COUNTY OF SANTA BARBARA PLANNING AND DEVELOPMENT

MEMORANDUM

RE: Planning Commission Hearing of December 8, 2021
Lacerte Appeal of BMO, LLC ADU
Case Nos. 21APL-00000-00029 and 21CDP-00000-00053
2305 Finney Street, Summerland, CA

(N) SITE PLAN
1" = 10'

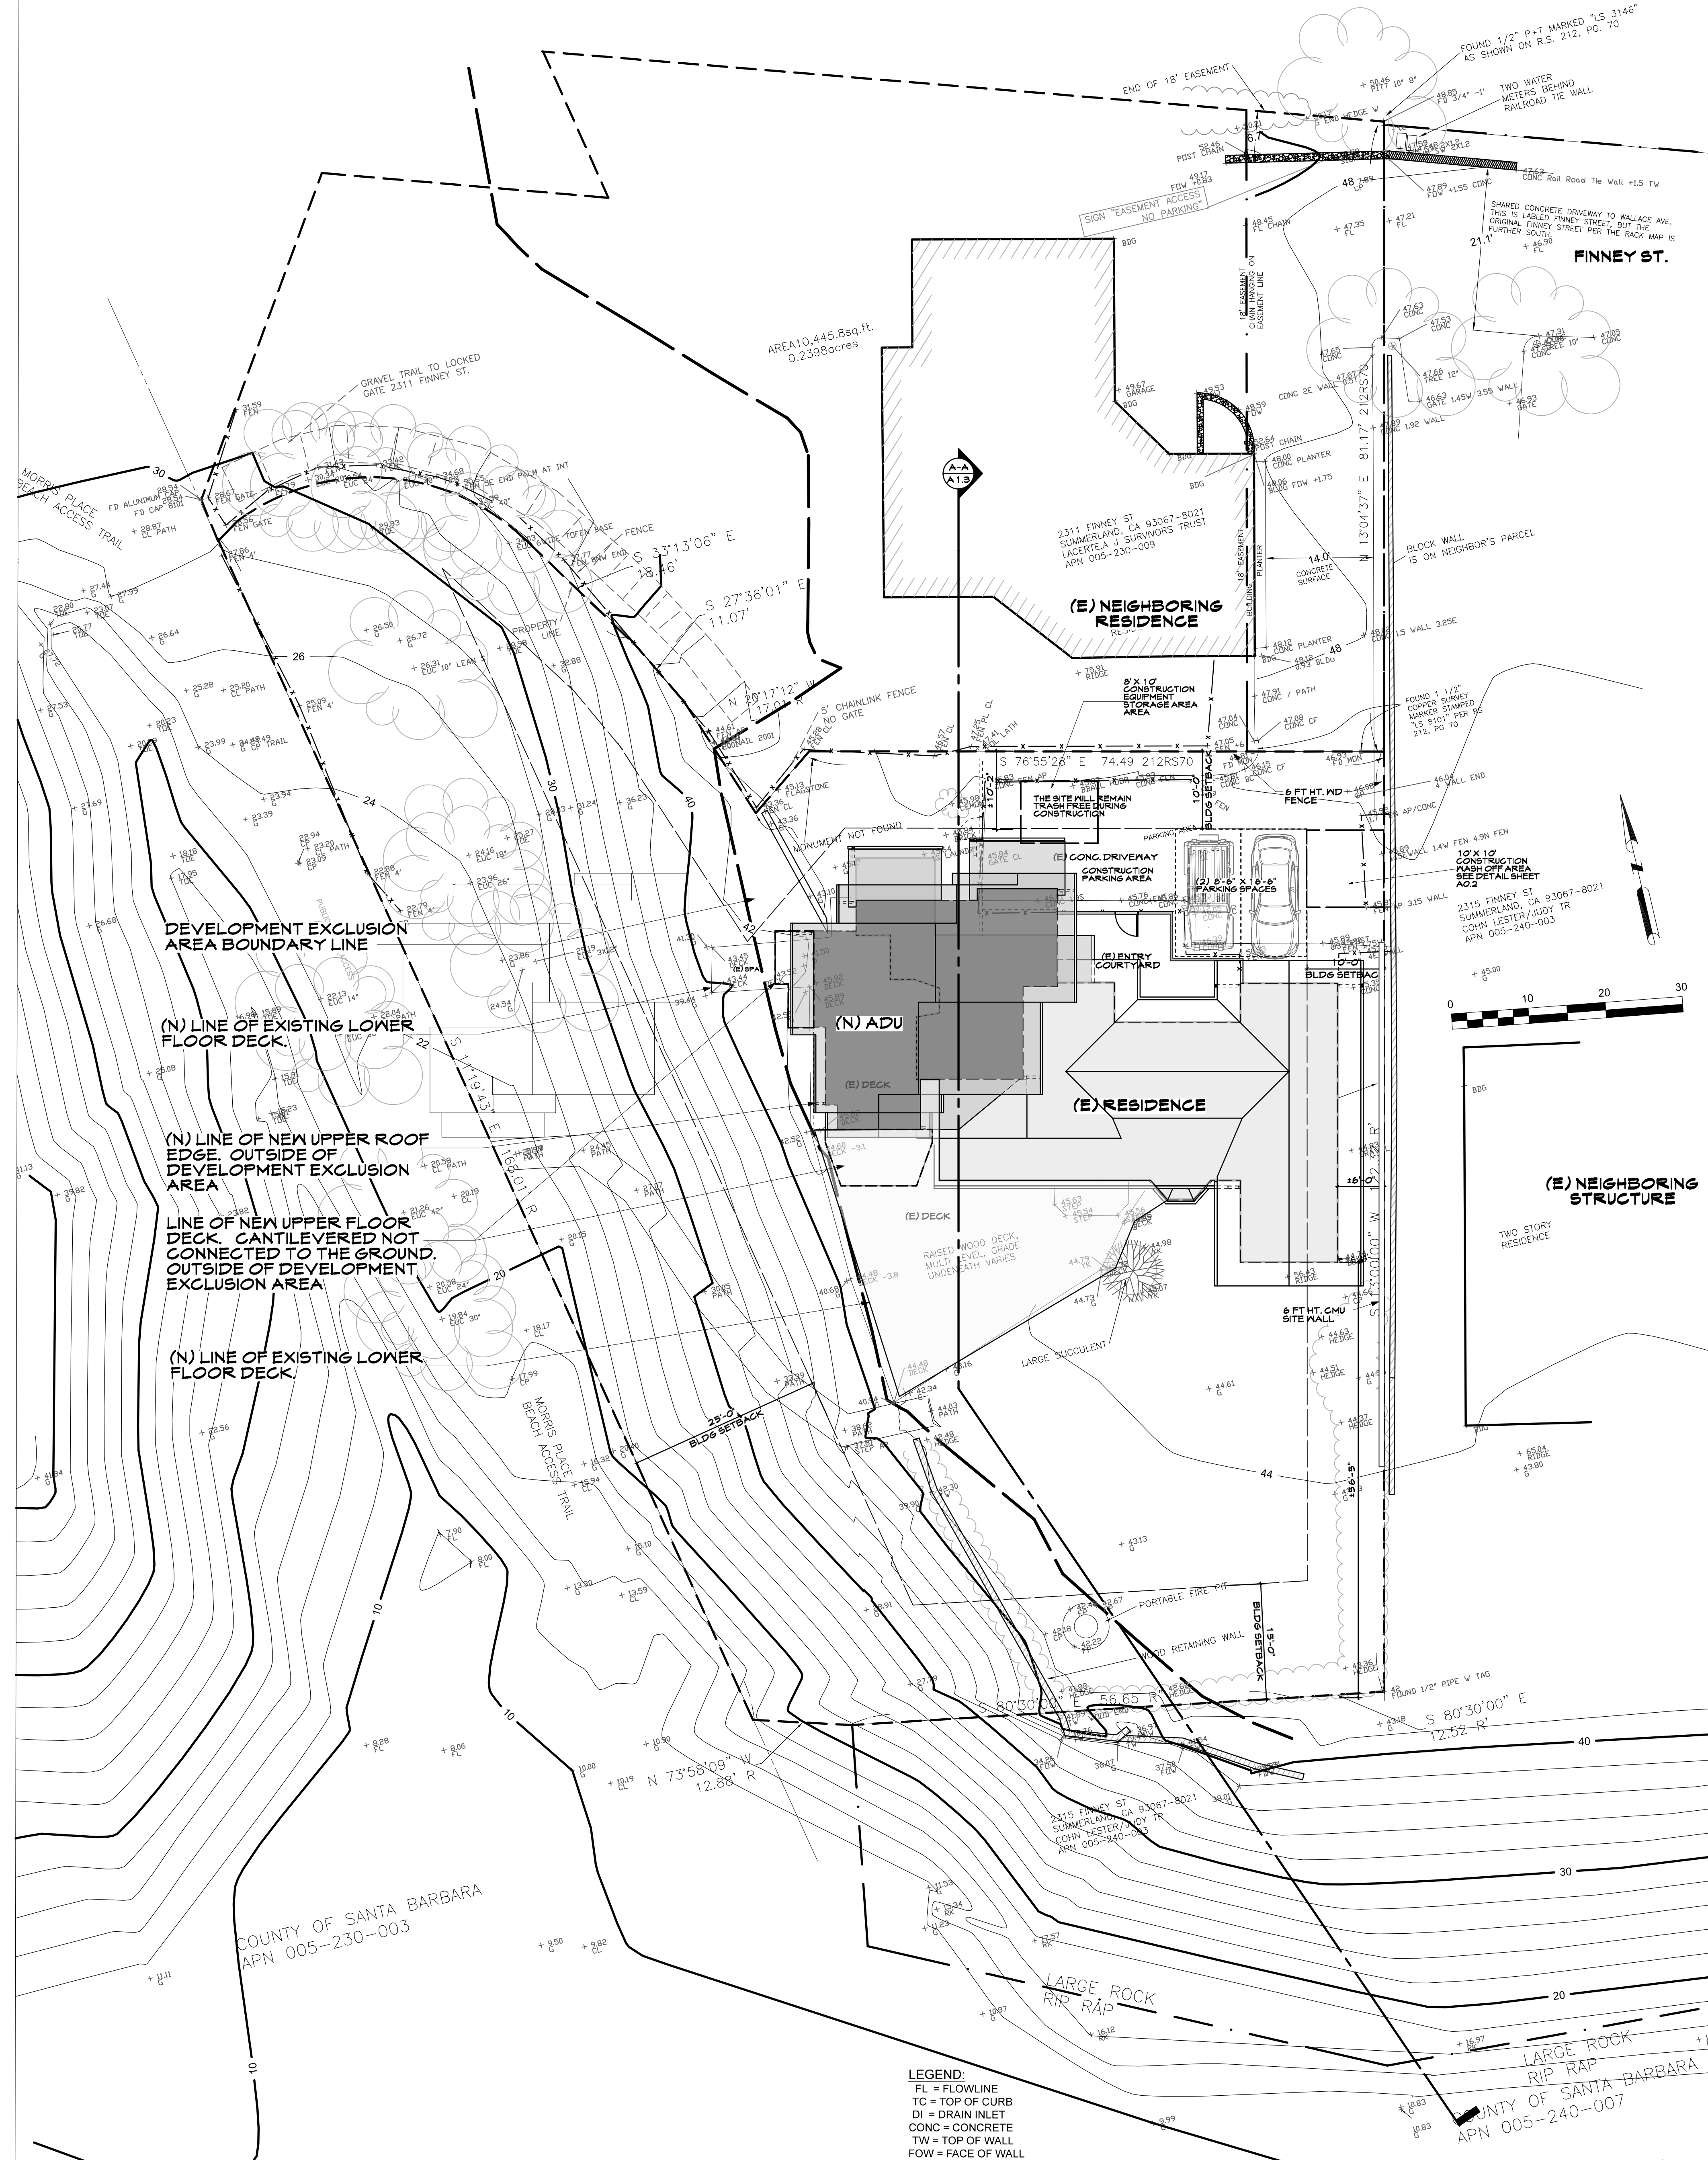
Issue #1. The appellant asserts that *“The subject site does not have street frontage and is accessed via a no parking easement off another no parking easement. The site currently has two uncovered parking spaces for a 4-bedroom house. The Summerland Community plan provides that new development on a lot the size of the subject site provide a minimum of four off street parking spaces... As currently proposed, the project does not provide adequate parking for the residents of the single-family dwelling, and an additional unit will increase the lack of parking and result in a negative impact to the available public parking to access the coast... Additionally, the plans show two cars in the remaining area in an attempt to demonstrate that the cars can be accommodated. These cars are not shown in a dimension required of off-street spaces and therefore the drawing is misleading,”* and that, *“There is a Court order in place reducing the number of parking spaces that the applicant has been using . . .”*

Additionally, the plans also show a new front porch projecting into the existing area for parking and circulation. The new area is proposed to project into this area by 11 feet. Any new structures placed into the area will further limit the ability of the occupants of 2305 Finney to comply with the easement restrictions, impeding parking and circulation.

Additionally, the plans show two cars in the remaining area in an attempt to demonstrate that cars can be accommodated. These cars are not shown in a dimension required of off-street spaces and therefore the drawing is misleading.

Staff Response to Issue #1. On-site parking for the single-family dwelling is consistent with ordinance requirements and no additional parking is required for the ADU. As discussed in Section 6.1 of the staff report, dated October 7, 2021, and incorporated herein by reference, the proposed project meets the parking requirements for the Single-Family Residential (7-R-1 Zone). Pursuant to Section 35-142.7 of Article II, additional parking spaces are only required for detached ADUs. Since this project is an attached ADU, no additional parking spaces are required. The Summerland Community Plan update required additional parking spaces based on lot size for all new single-family dwellings approved after June 9, 2016. The existing single-family dwelling was constructed in 1949, and the expansion to 1,638 square feet was legalized through approval of the Lot Line Adjustment and associated permits in 2003. Thus, additional parking spaces are not required.

The existing single-family dwelling has two parking spaces in the existing driveway. The proposed ADU does not reduce the number of parking spaces currently provided for the existing single-family dwelling. The dimension required of off-street parking spaces for residential uses is 8.5 feet wide by 16.5 feet long, pursuant to Section 35-114 of Article II. The spaces shown are 8.5 feet by 16.5 feet, and therefore comply with the required parking standards. In addition, the proposed project provides adequate parking without relying on the parking area referenced in the Court order submitted by the appellant.

SOUTH (REAR - OCEAN FACING) ELEVATION
1/4" = 1'-0"

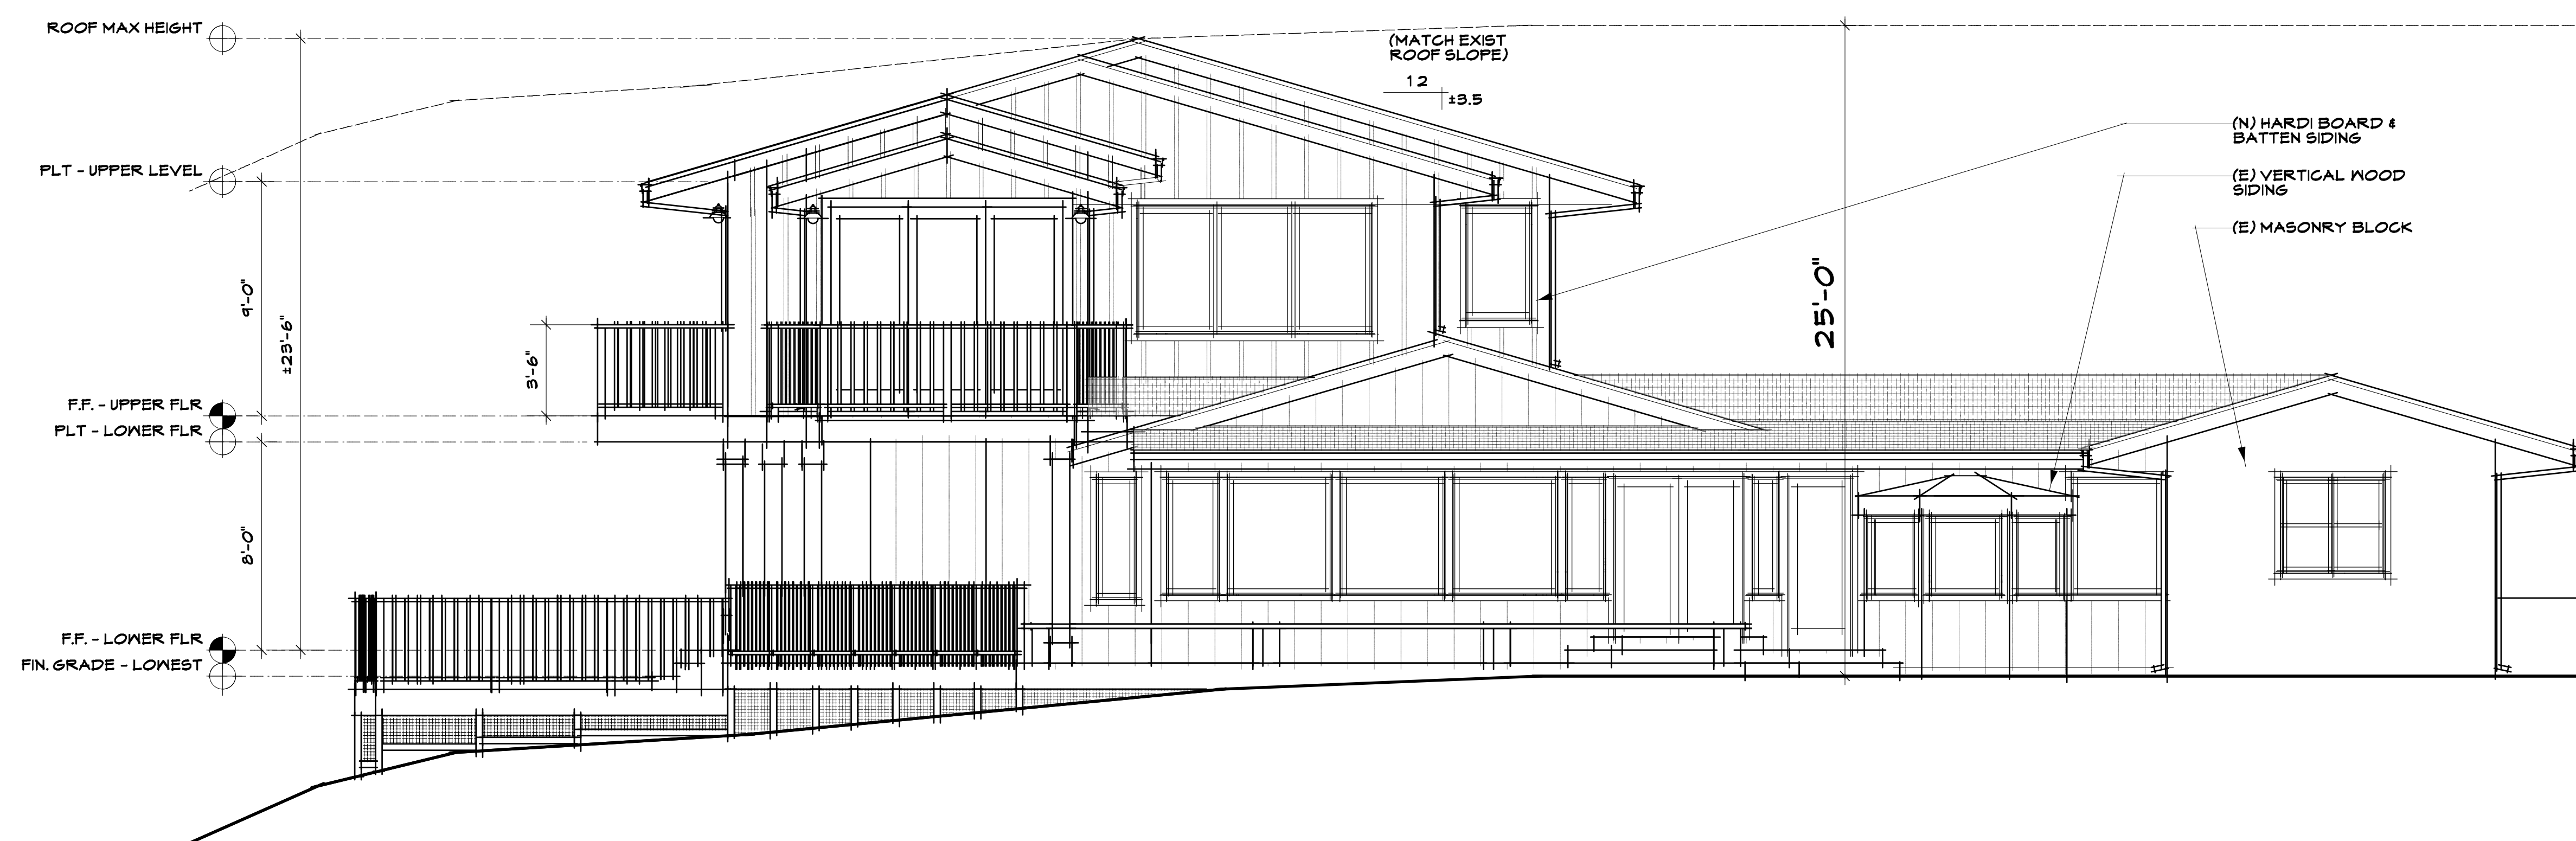
Issue #9. *The appellant asserts that the project lacks adequate lighting.*

Staff Response to Issue #9. The project does not lack adequate lighting. There is one lighting fixture proposed at the entrance to the ADU (see sheet A4.2 of the project plans, Attachment A). Pursuant to Section 35-139 of Article II, all exterior lighting shall be hooded and no unobstructed beam of exterior lighting shall be directed toward any area zoned or developed residential, or toward any environmentally sensitive habitat area. The proposed lighting fixture is hooded and the lighting is directed downward, in compliance with this requirement.
